Access Compliance Report

Public Rights-of-Way

(Curb Ramps)

Intersection ID: 26040	Main Street: NORTH_COURSE_DR	Cross Street: ROUNDING_RUN_RD	Location: NE
ADA ID: 286A4EED9F21	Ramp Type: PerpDiag	Initial Pass/Fail: Fail	Overall Compliance: No
			Severity Score: 26.25

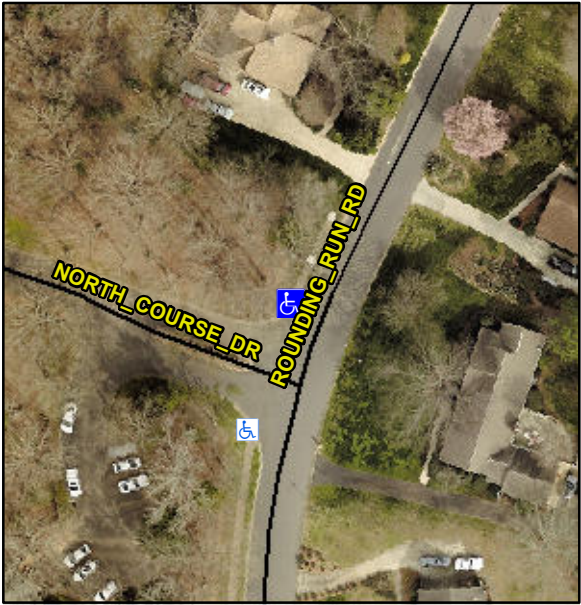
Codes/Mitigation Info/Possible Solution		Field Measurements/Component Compliance			
	Possible Solutions:				
	Remove & Replace Curb Ramp With Two New Directional Ramps or Equivalent.				
	Surveyor Notes:				
	N/A				
	PROW/ADA:				
	Not Found, R304.2.2, R304.5.3				
	Street 1 Name	NORTH COURSE DR		Stop Condition-Street 2	StopSign
	Street 2 Name	ROUNDING RUN RD		Stop Condition-Street 1	None
	Total Cost:	\$	3200.00		
		Compliance	Description	Data	Compliance
		N/A	Ramp Length (in)	48.0	No
		Yes	Ramp Width (in)	48.0	No
		N/A	Flare Type LT	N/A	N/A
		N/A	Flare Slope LT (%)	N/A	N/A
		N/A	Flare Traversable LT?	N/A	N/A
		N/A	Landing Length (in)	N/A	N/A
		N/A	Landing Width (in)	N/A	N/A
		N/A	Landing Slope (%)	N/A	N/A
		N/A	Landing X Slope (%)	N/A	N/A
		N/A	Landing Curb? (Y/N)	N/A	N/A
		N/A	Shared Landing?	N/A	N/A
		N/A	Gutter Ponding?	N/A	N/A
		N/A	Gutter Lip Ht (in)	N/A	N/A
		N/A	Painted X Walk1?	No	N/A
			X Walk 1 Direction	To SW	X Walk 2 Direction

N/A	X Walk 1 Width (in)	N/A	N/A
			X Walk 1 Slope (%)	6.9	X Walk 2 Slope (%)
			X Walk 1 X Slope (%)	4.7	X Walk 2 X Slope (%)
		N/A	Ramp inside XWalk1?	N/A	N/A
			Road Slope (%)	5.5	N/A
			Road X Slope (%)	1.1	N/A
		N/A	Any Obstructions?	N/A	N/A
			Obstruction Type		
				N/A	N/A
				Yes	Surface Condition? (G/P)
					Good
